Attachment B1

Selected Drawings

PROJECT
2235 BILLYARD 21C
DRAWN SENIOR QA APP'D
MP CM WS

DWG TITLE
LEGEND, DRAWING LIST, SITE MAP
DWG NO REV
DA000 J

1 O L02

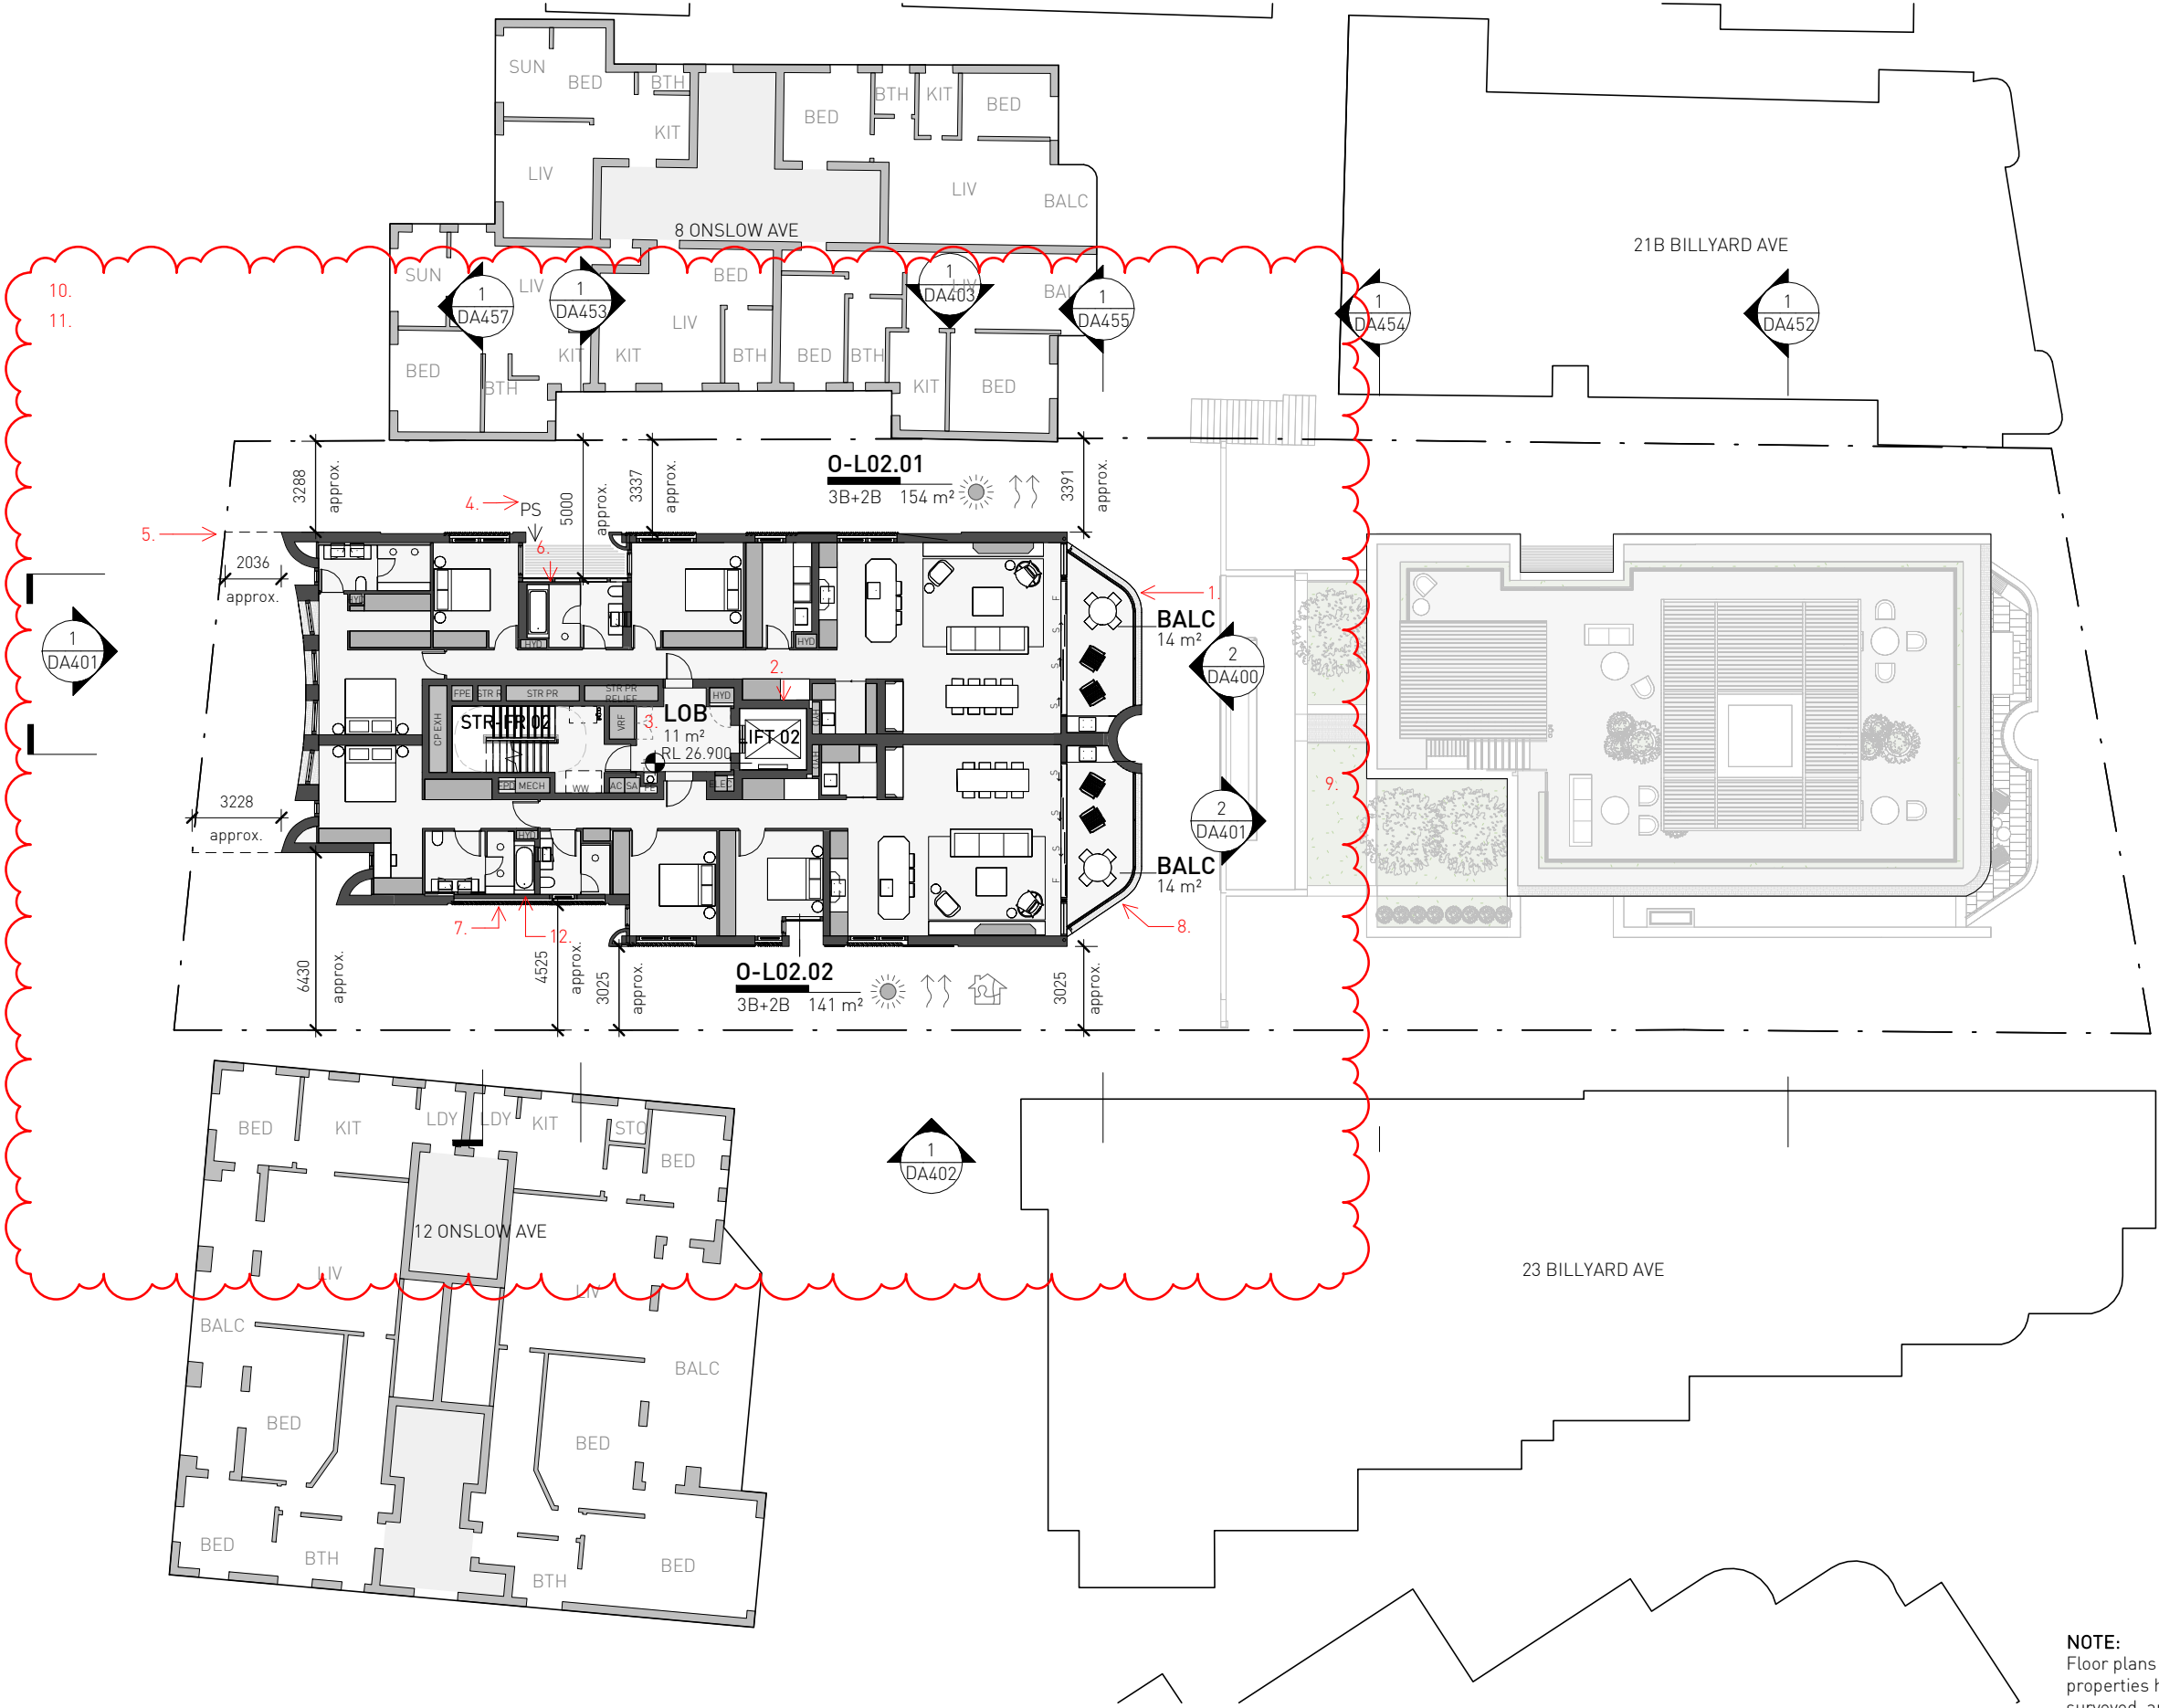
1. N-W Onslow balcony straightened not to exceed height plane demarcation line. Balcony size adjusted to 2.4m.

2. Core length decreased, risers revised.

3. Waste Chute removed. Risers revised.

4. Horizontal privacy screen added to building indents.

5. Onslow front setback increased by 1.8m.

6. Facade adjusted to increase bathroom size.

7. Louvred screen & brick extent adjusted.

8. Balconies splayed.
- DA ISSUE 07:
9. Back of Billyard form & planters adjusted for solar compliancy.

10. Structural elements, service risers, windows position, apartment layouts updated.
- DA ISSUE 09:
11. Detailing of services, structural elements & perimeter walls, also including:

12. Solid wall extended & glass reduced.

1 O L03

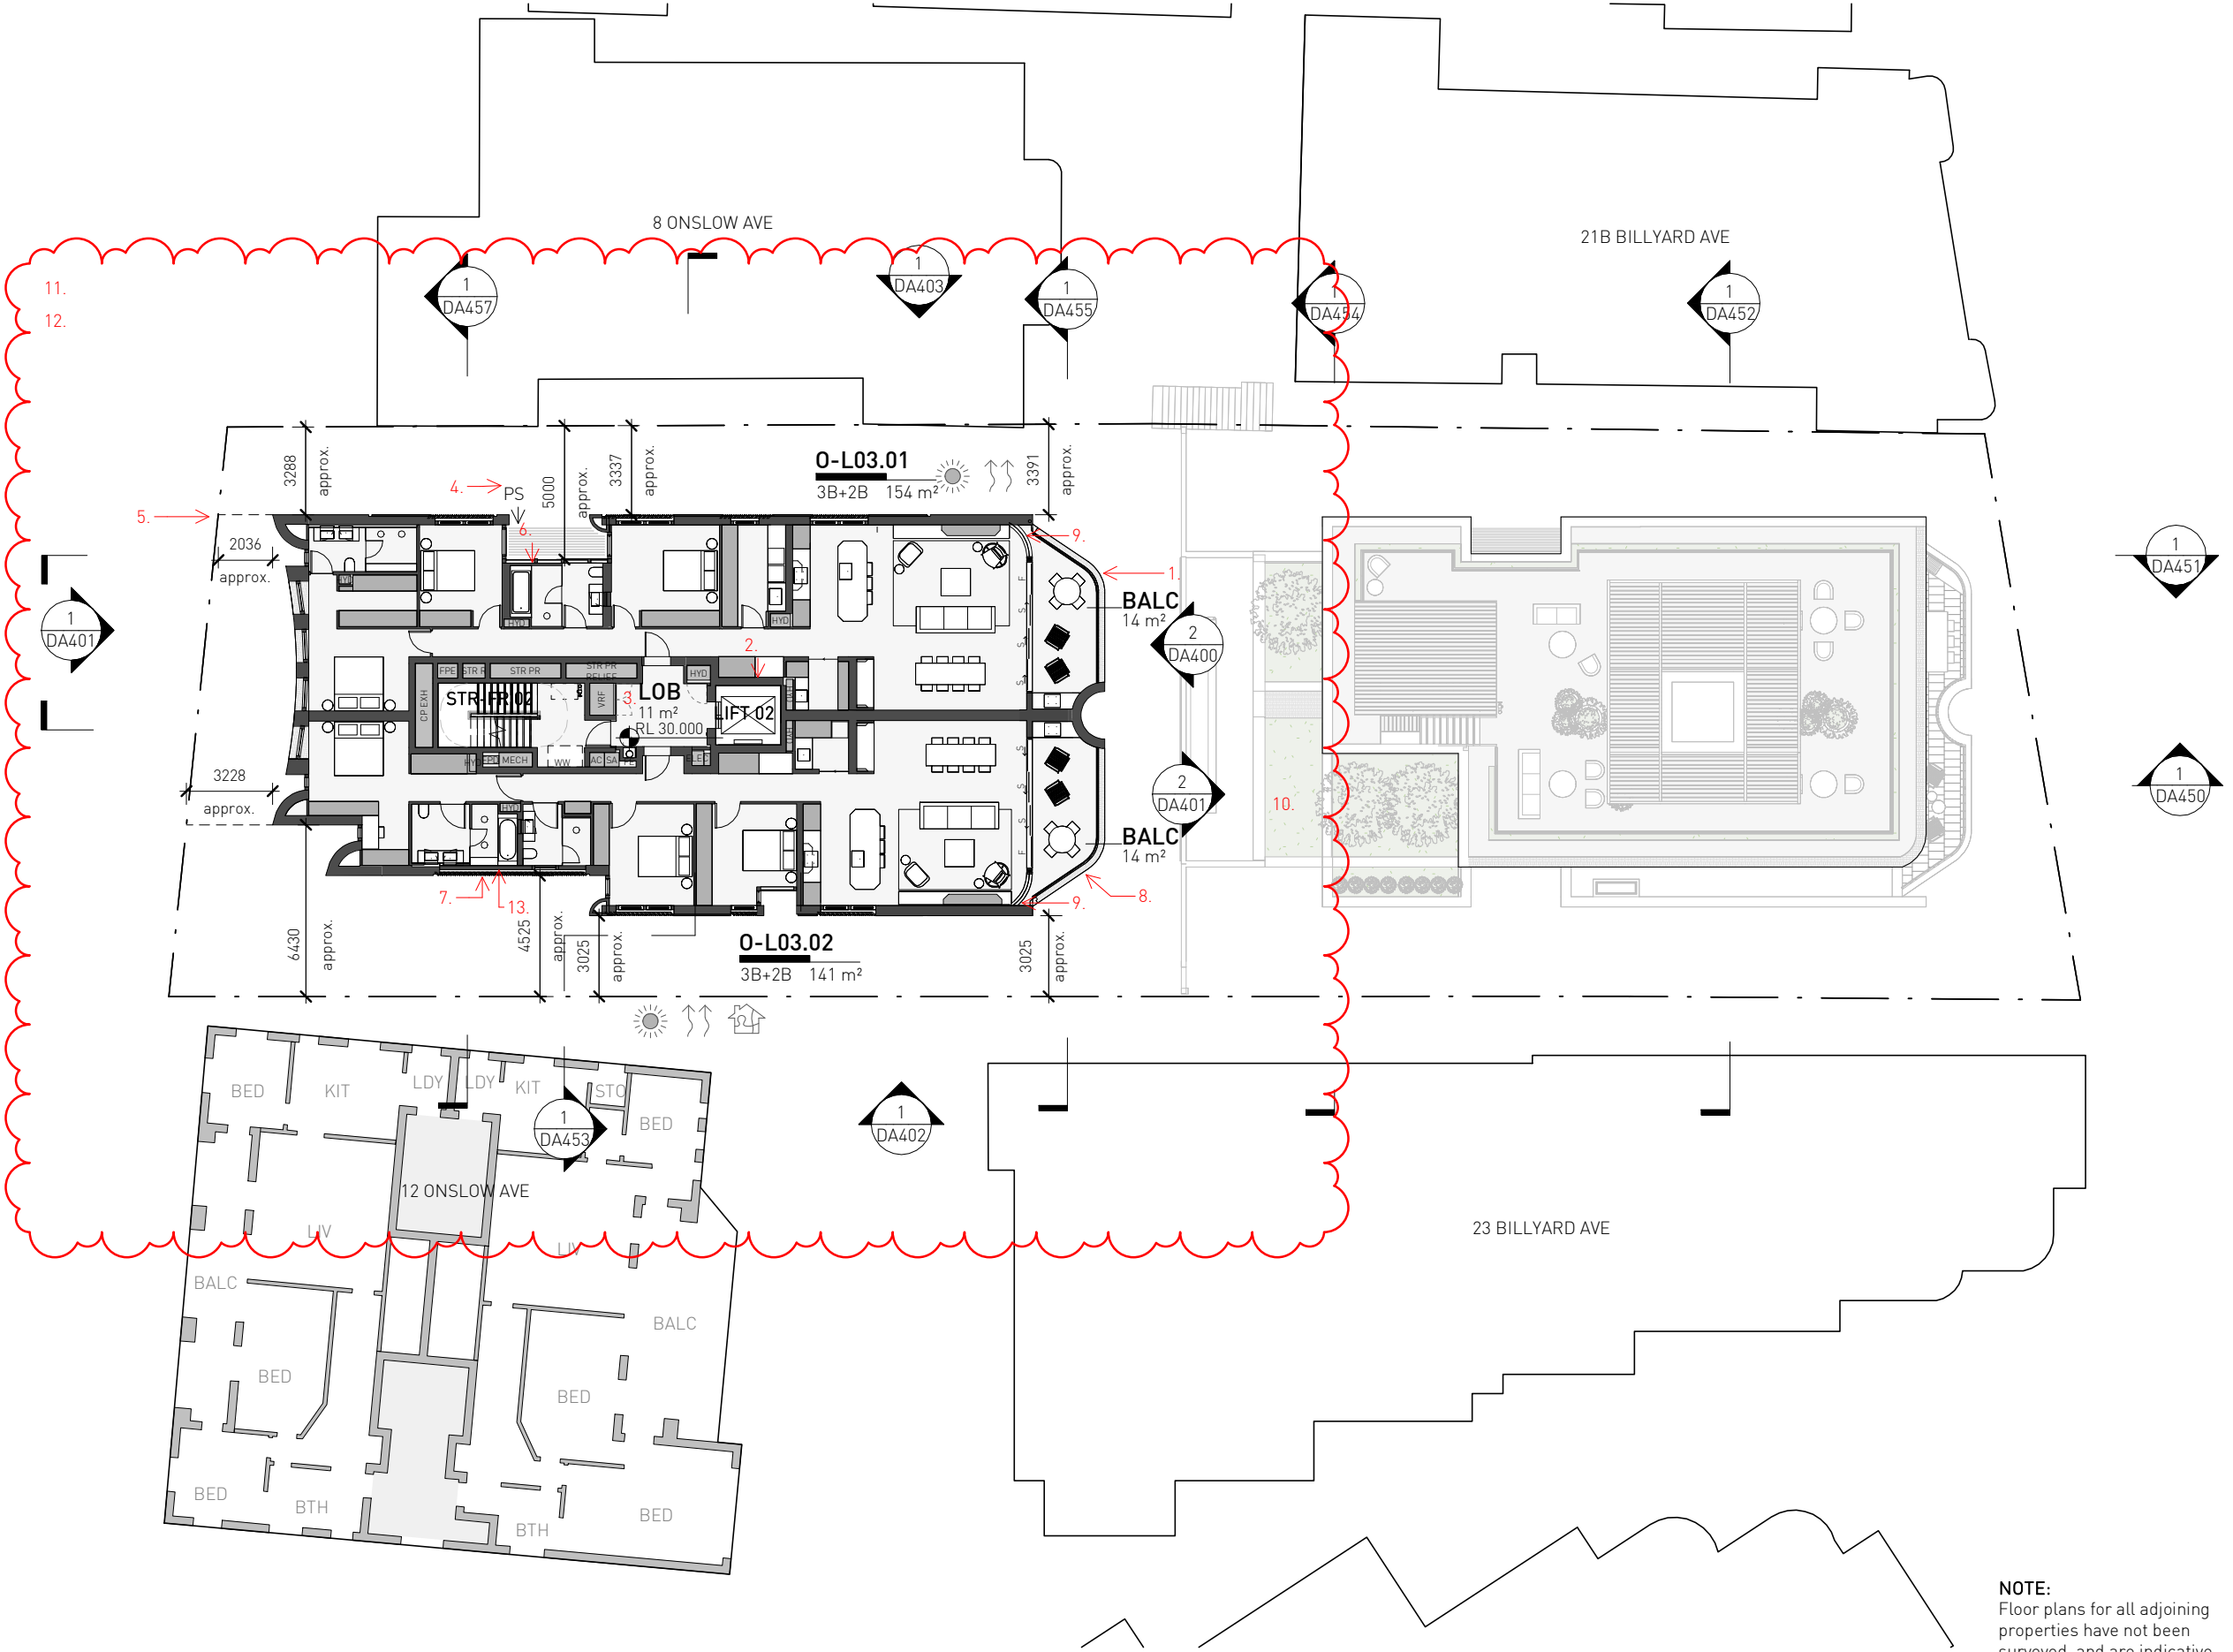
1. N-W Onslow balcony straightened not to exceed height plane demarcation line. Balcony size adjusted to 2.4m.

2. Core length decreased, risers revised.

3. Waste Chute removed. Risers revised.

4. Horizontal privacy screen added to building indents.

5. Onslow front setback increased by 1.8m.

6. Facade adjusted to increase bathroom size.

7. Louvred screen & brick extent adjusted.

8. Balconies splayed.
- DA ISSUE 07:
9. Glass line splayed for solar compliance.

10. Back of Billyard form & planters adjusted for solar compliancy.

11. Structural elements, service risers, windows position, apartment layouts updated.
- DA ISSUE 09:
12. Detailing of services, structural elements & perimeter walls, also including:

13. Solid wall extended & glass reduced.

1 ELEV SOUTH (FRONT)

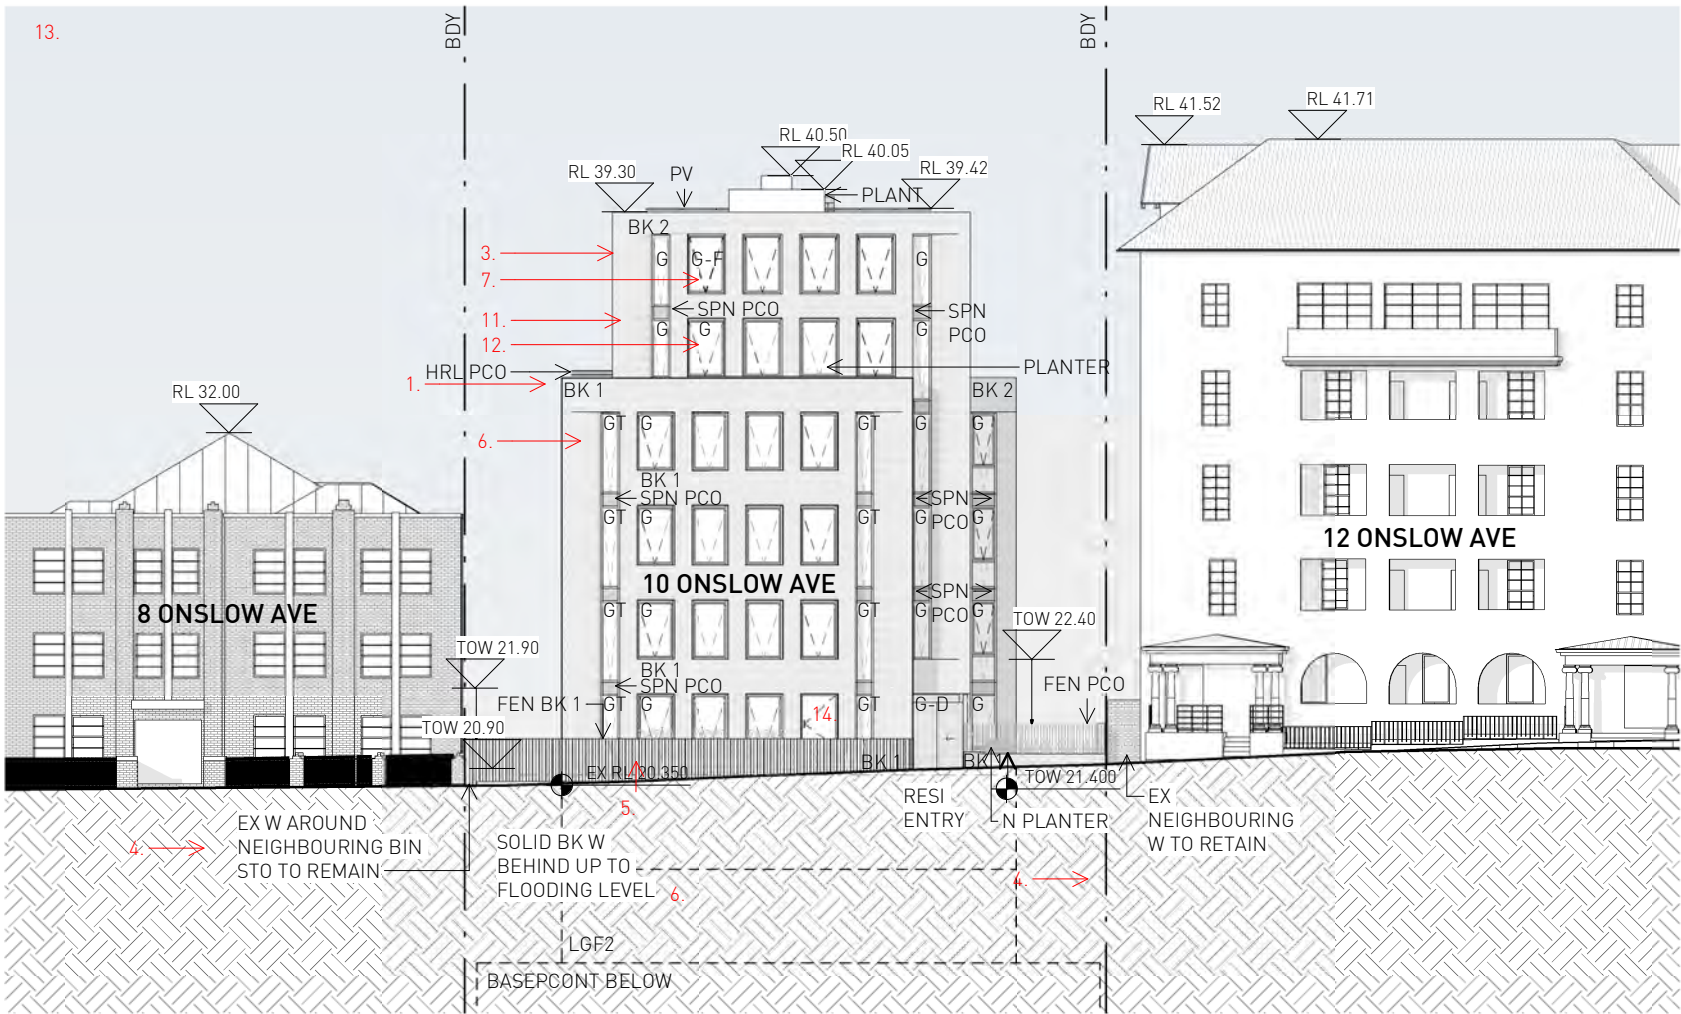
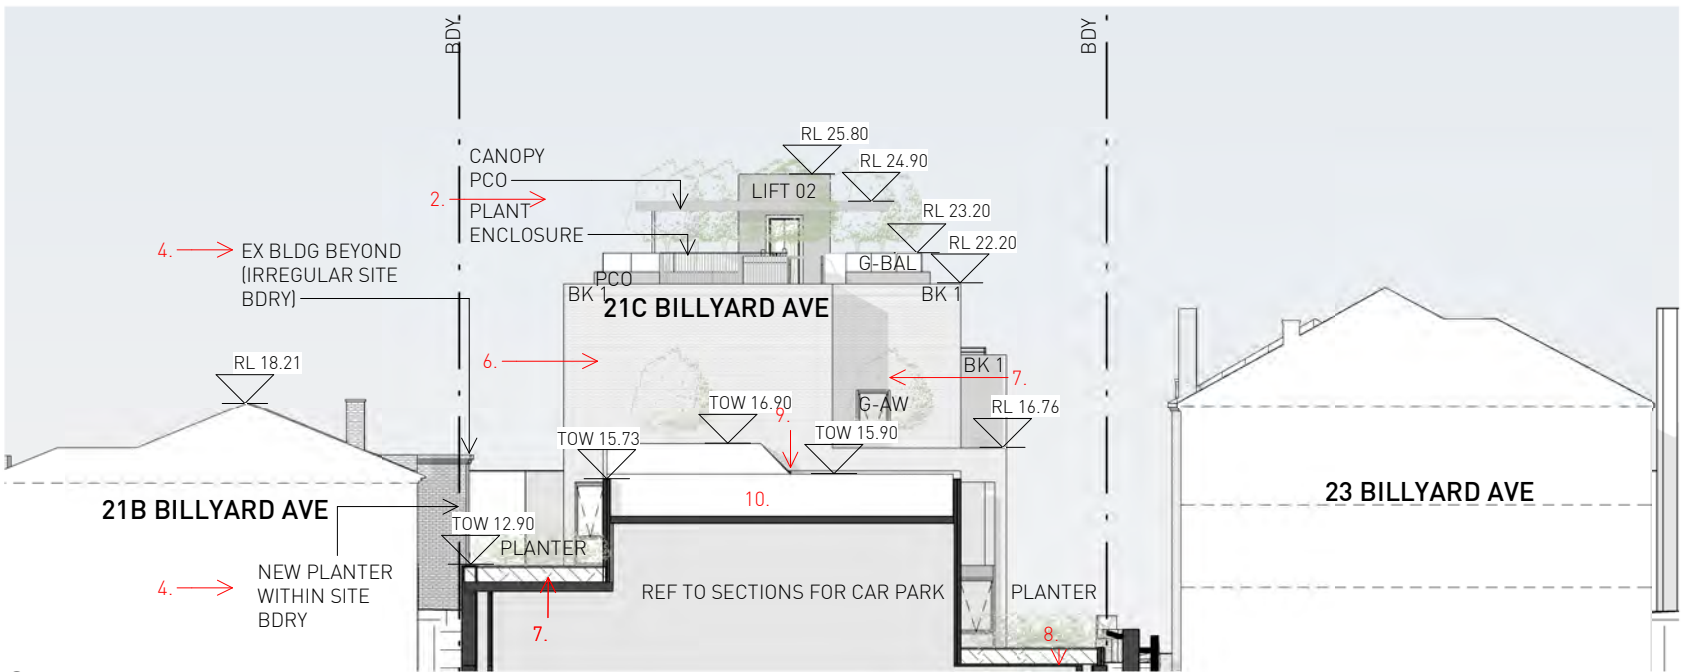
- 1. Sill added to windows to allow planter area (used to be terrace).
 - 2. Billyard Rooftop area allocated to communal open space. Private Penthouse Terrace removed. Shading structure added. Plant enclosure added.
 - 3. Side setbacks of upper form increased.
 - 4. Boundary condition clarified.
 - 5. BK fence added.
 - 6. Solid elements up to RL 20.90 for flooding barrier.
 - 7. Planters level dropped.
- DA ISSUE 07:
- 8. Planter level dropped.
 - 9. Back of Billyard pushed down for solar compliance to 23 Billyard. Wall height adjusted, chamfer added.
 - 10. CP INT shifted. Graphics corrected.
 - 11. Brickwork pattern updated.
 - 12. Glazing details updated.
- DA ISSUE 09:
- 13. Detailing of facades, brickwork, openings shown, including:
 - 14. Door added to O-GF.
